**County of Nevada  
Information & General Services Department  
Purchasing Division**

**ADDENDUM NO. 3 (Redesign)  
McCourtney Road Transfer Station  
(MRTS) Improvement Project**

**Addendum Release date: January 4, 2023**

1. Seven sheets have been modified for this addendum; Architectural pages 02A203, 02A302, 02A303, 02A504, and Structural pages 02S402, 03S103 and 03S302, and have been uploaded as two separate documents in Public Purchase

SHEET  
02A504

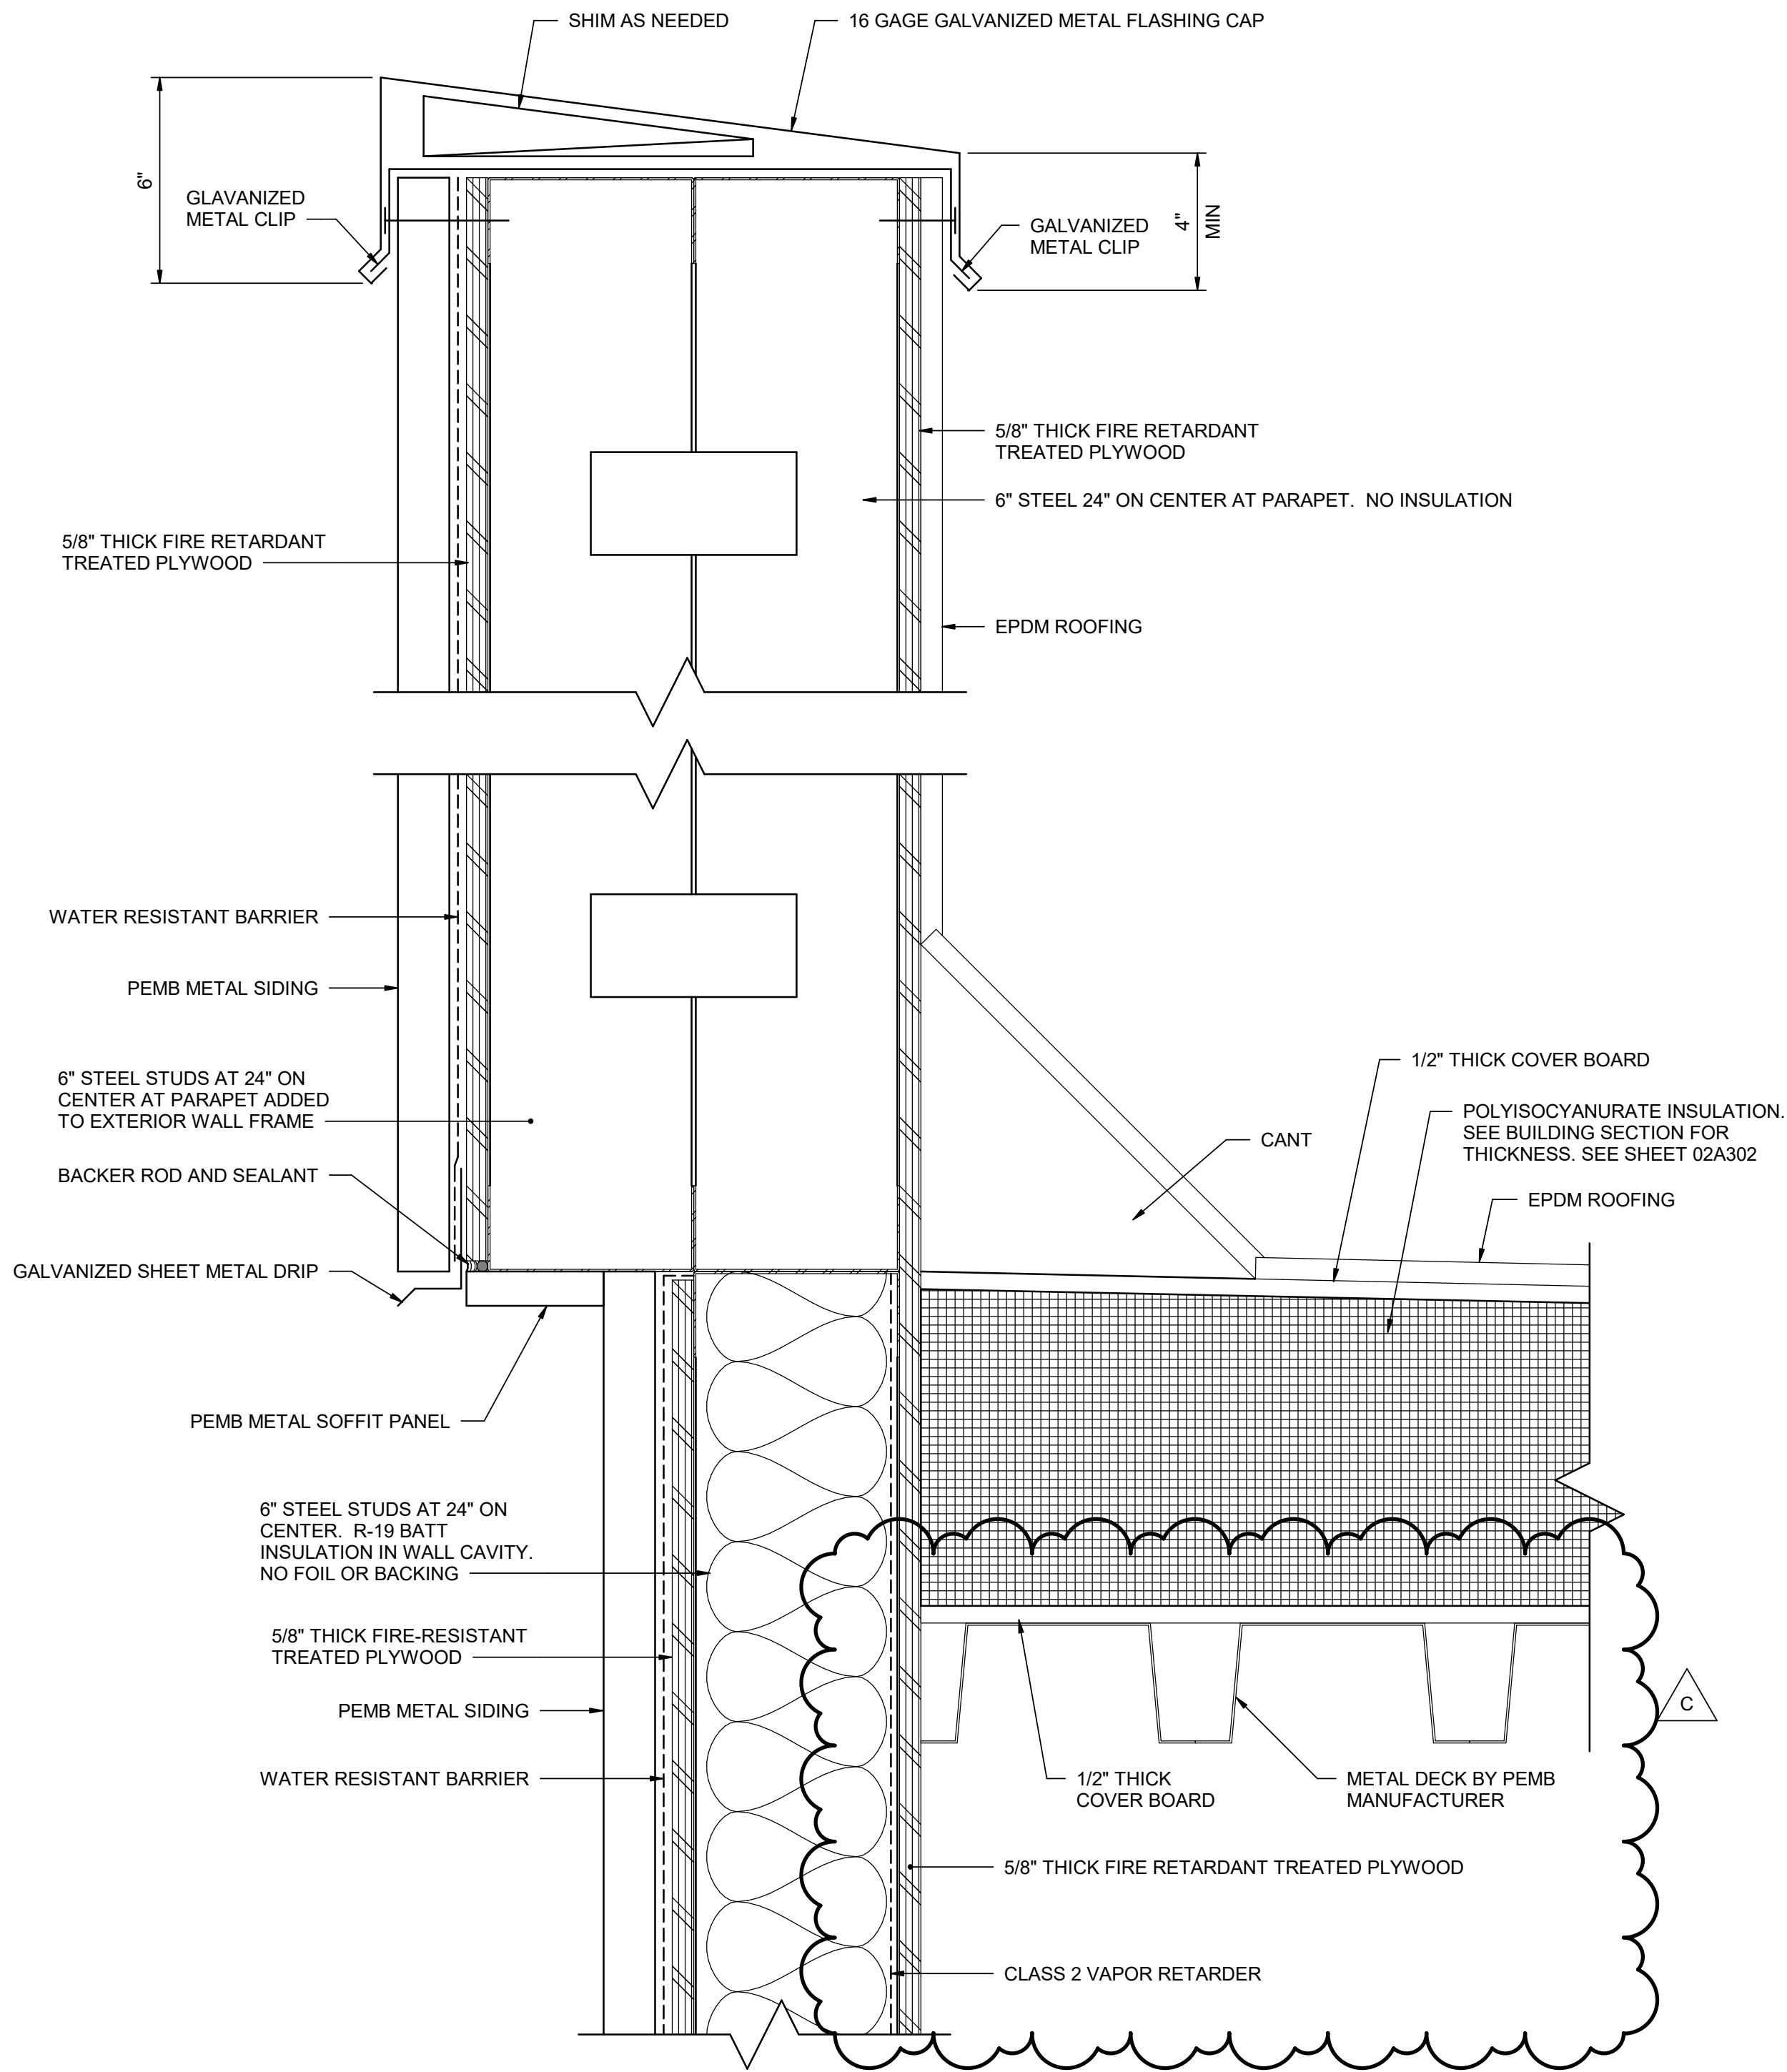
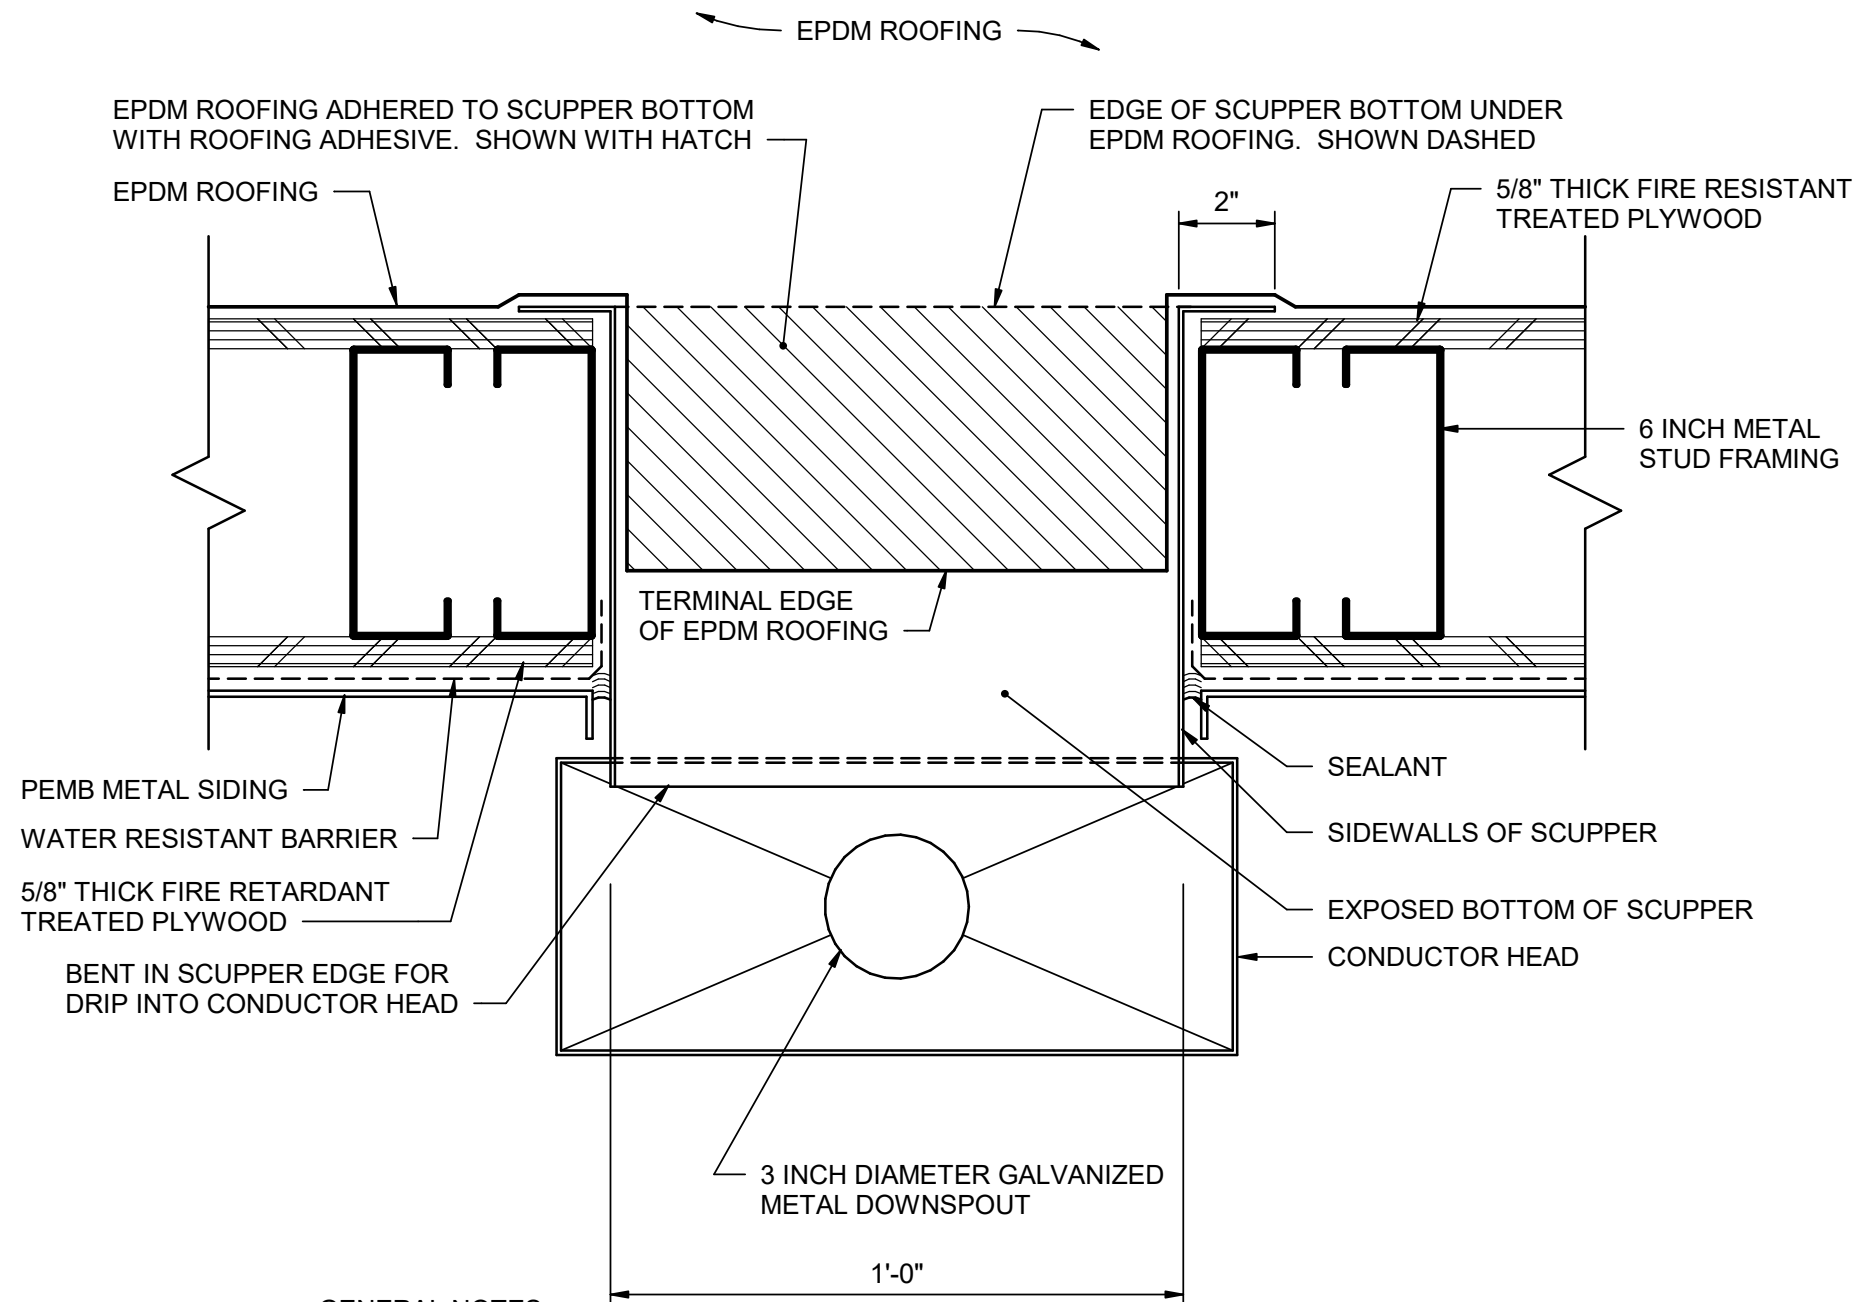
3.	<p>Reference 02A504 seems to call out plywood decking; 02S402 seems to call out metal roof decking. Q - Please clarify</p>	<p>The detail will be revised to show metal roof decking instead of plywood. In the essence of time, this response will suffice as acknowledging this clarification.</p>
